Fresno Unified School District Education Center Remodel Project

Historic Preservation questions and concerns:

EXHIBIT 2B

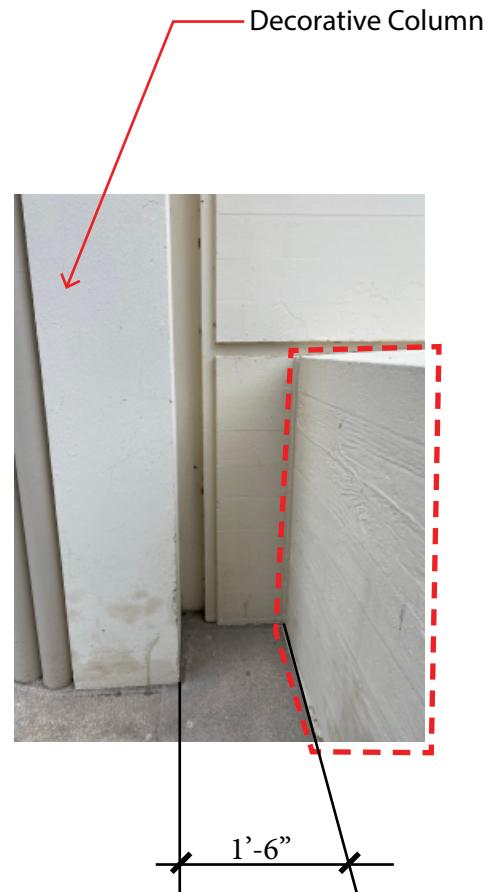
3. What are the impacts to the decorative columns surrounding the door entrances, given the size and scale of both ramps?

What are the impacts to the decorative columns surrounding the door entrances, given the size and scale of both ramps?

No Impact - There is +1'-6" space between the decorative column and the demo/new work.

EXHIBIT 2C

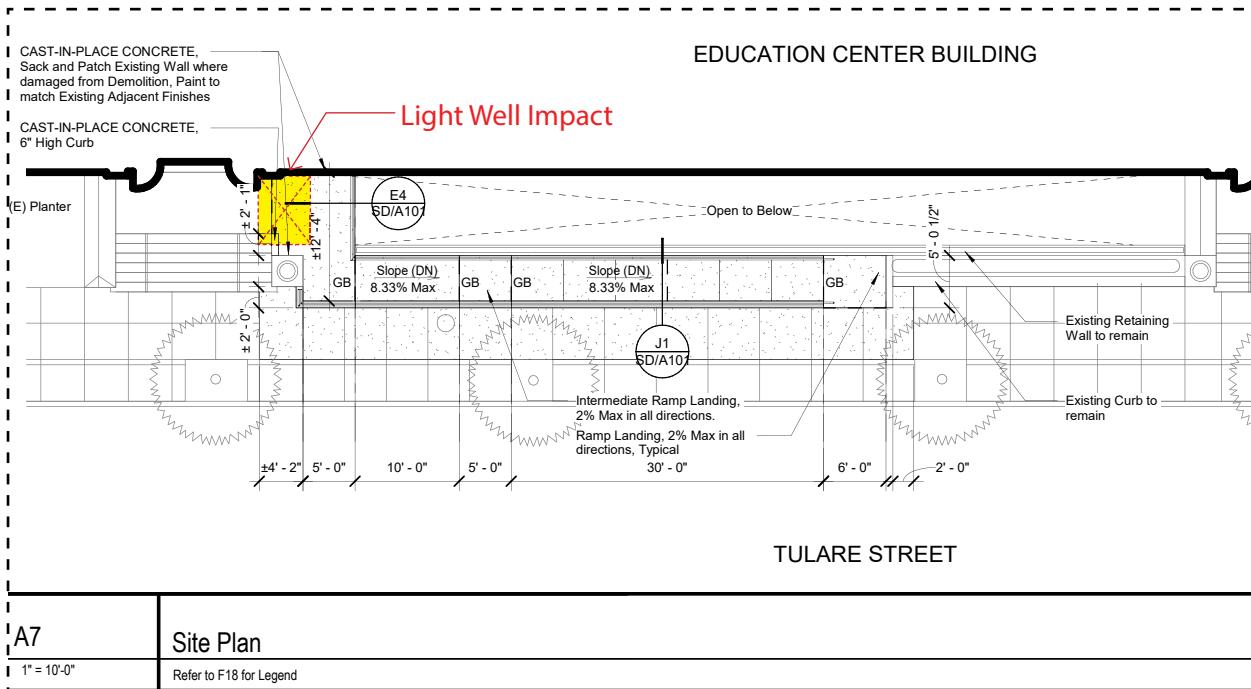
6. What are the plans for the light well?

1. What are the plans for the light well?

The ramp was design to keep the light well open to below to allow light into the Basement.

Approximately 5'-0" x 6'-7" of the light well at the West end will be covered to accommodate the Ramp landing. Refer to **Site Plan on A7-SD/A101**.
